NewRange Request to Supplement Environmental Impact Statement
Finding of Fact 70l - Query 9

From: Johnson, Bill H (DNR) <bill.johnson@state.mn.us>
Sent: Sunday, August 9, 2026 11:44 AM
To: Christie Kearney <christie.kearney@newrangecoppernickel.com>
Cc: Oswald, Caroline (She/Her/Hers) (DNR) <caroline.oswald@state.mn.us>
Subject: NWR: EXTERNAL SENDER Query 9 - Existing Pits at Proposed TSF

Hello Christie. This is Query 9 to support DNR's consideration of NewRange's request and material evidence for the NewRange NorthMet Mining Project.

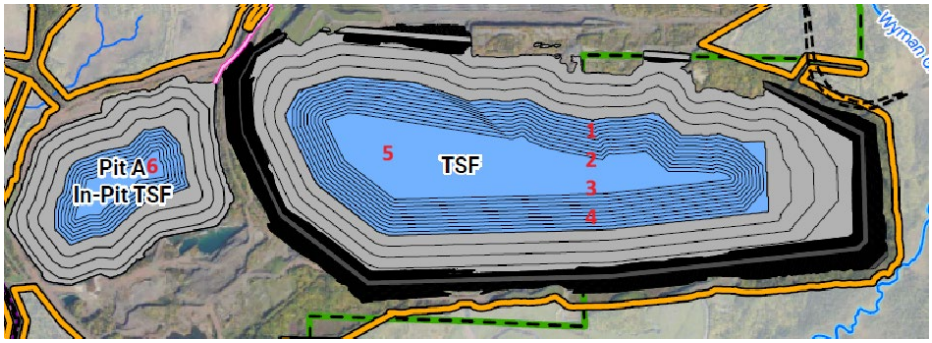
Below is a Google Maps screenshot of the existing site being described in the text excerpt. There are six historic "pit" features that have been numbered for reference purposes.

1. Below is a cutout of Figure 3 from the SEIS Request document for the proposed Pit A In-Pit TSF and TSF. Do the numbers added to it correctly correspond to the pit features listed above in the Google Maps image of the proposed site?

2. Do "pits" 1-6 depicted on the Google Maps image have specific historic names or designations back from the LTVSMC operating period? Right now the document just identifies them as "former Area 2/3 mine pits" although the in-pit TSF is referenced as "Pit A" (that may or may not be historic).

NewRange Response: I am attaching a figure from the 404 permit application, Large Figure 17, that show the location of the pits through the footprint of the Pit A In-Pit TSF and TSF. The locations you show above are not quite accurate, as the legacy pits are further north and northwest of your indicated numbers.

NewRange Response: I am attaching a figure from the 404 permit application, Large Figure 3, that shows the naming convention we have given the four legacy pits in this area: Pits A, B, C, and D. There are historic names for these pits from LTVSMC's operating period, but we are not using them for the NorthMet Project, with the exception of Pit 3, northeast of these pits. The historic names do not differentiate the smaller pits well. For your documentation purposes, Pit A corresponds with LTVSMC Pit 2W and Pits B, C, and D correspond with LTVSMC Pit 2E.
